# Camping provision in the National Park and the Loch Achray campsite

## The main flaws in the proposed Loch Achray campsite

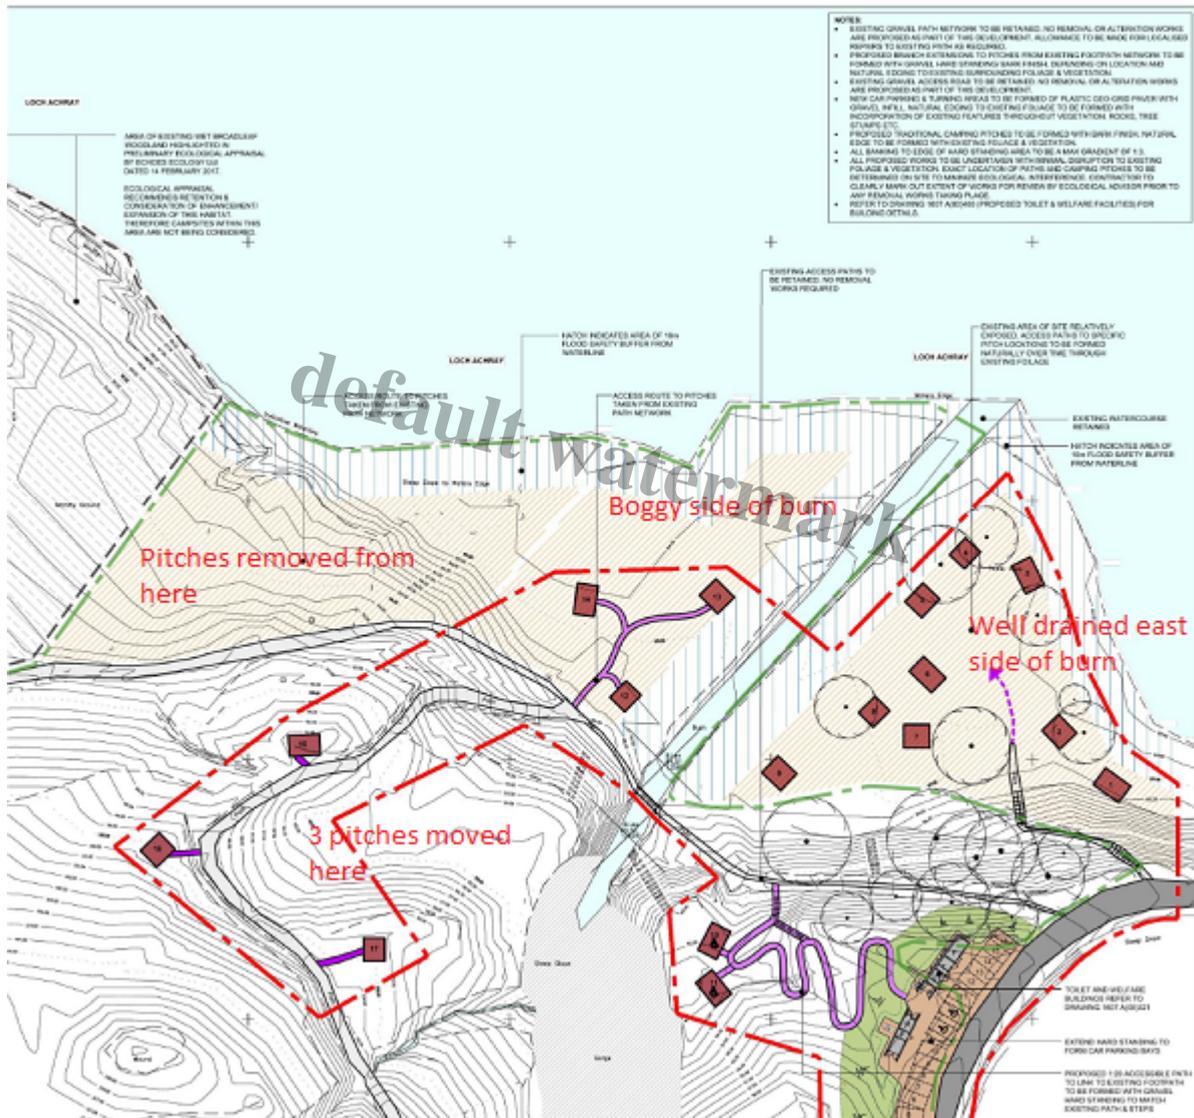
The most obvious changes to the application is that the proposed sites for three pitches have been moved

## 2.3 Off Site Management / Resources

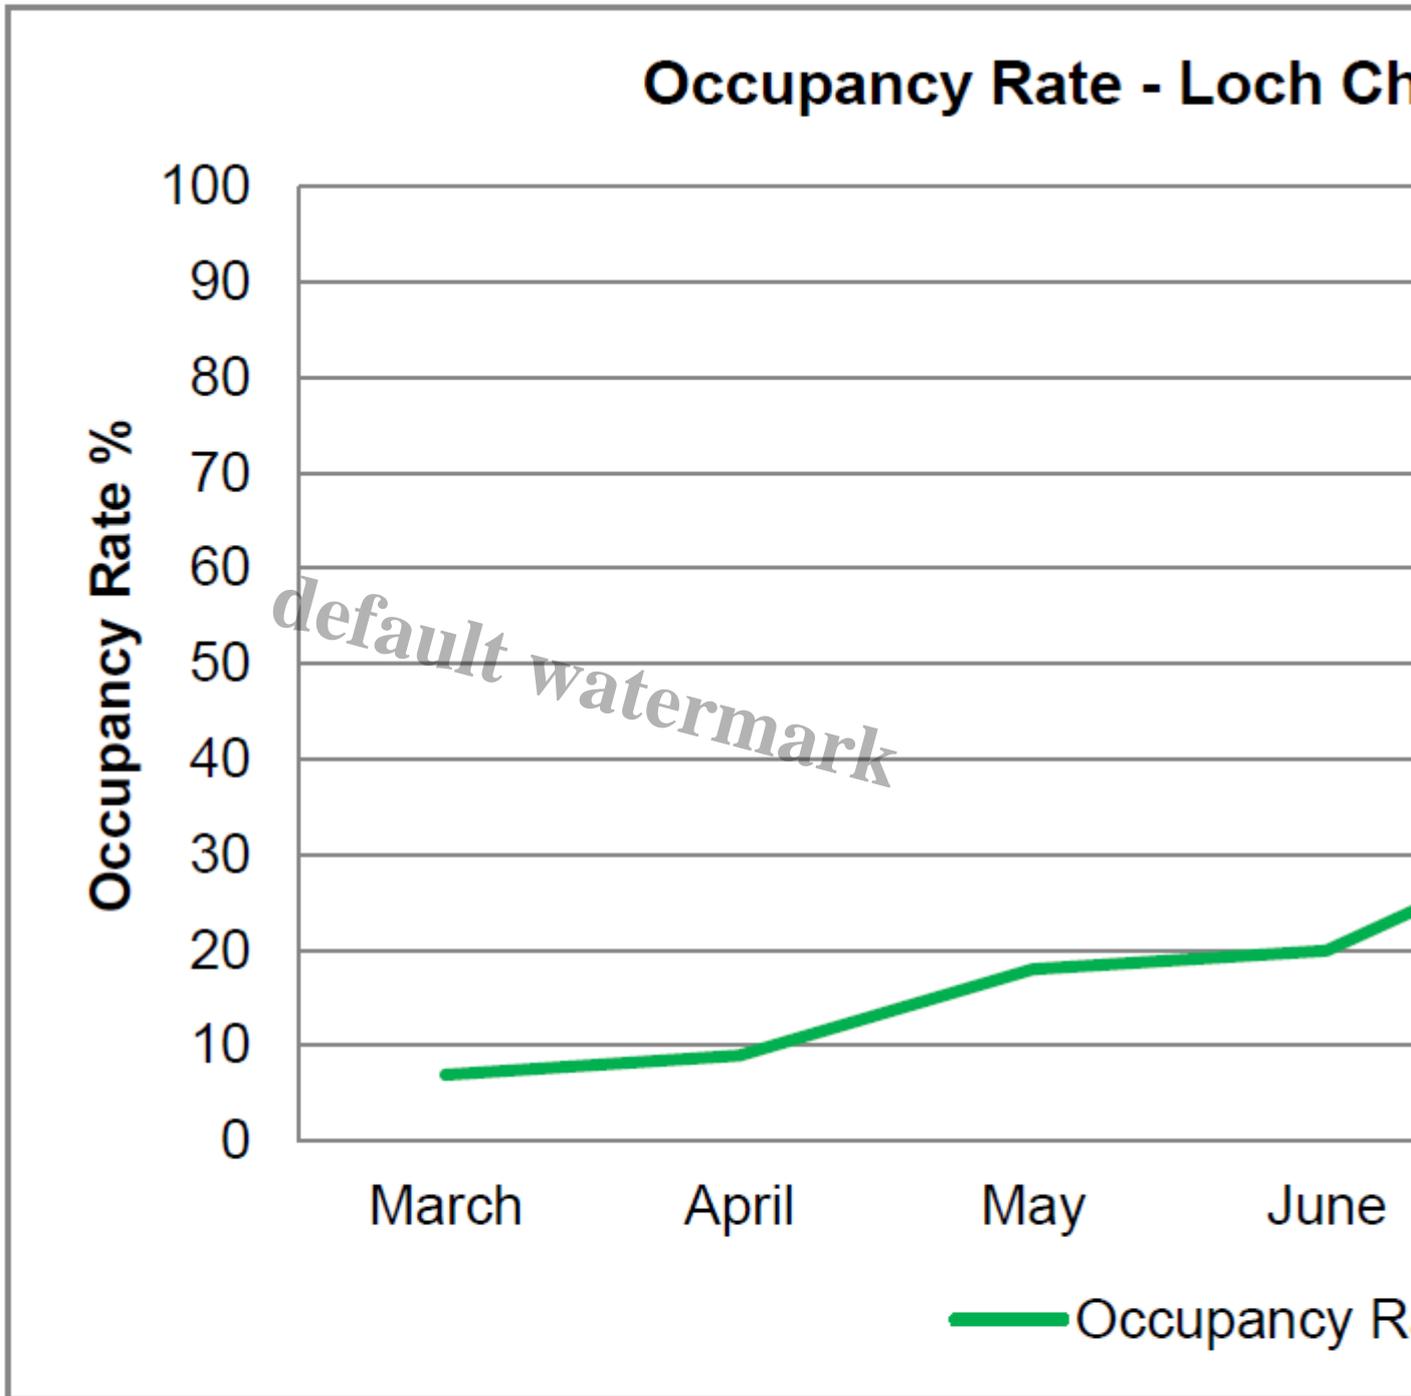
This is madness which appears driven by the need to get SEPA to withdraw their objection. The Loch Achray site is actually much better and safer for camping than some of the camping permit areas

created by the Park which are regularly underwater and unusable (e.g the beaches at Firkin Point). The difference though is the permit areas never required planning permission. More hypocrisy from the LITNPA and other agencies. Should SEPA not have been objecting to many of the permit areas because of their flood risk?

The cost implications of this staffing are significant. 10 hours at even Â£10 per hour (minimum wage plus on costs) is Â£100 a day. 17 places are planning and lets the campsite does twice as well as Loch Chon, which was always too big and is more remote and whose occupancy is as follows:
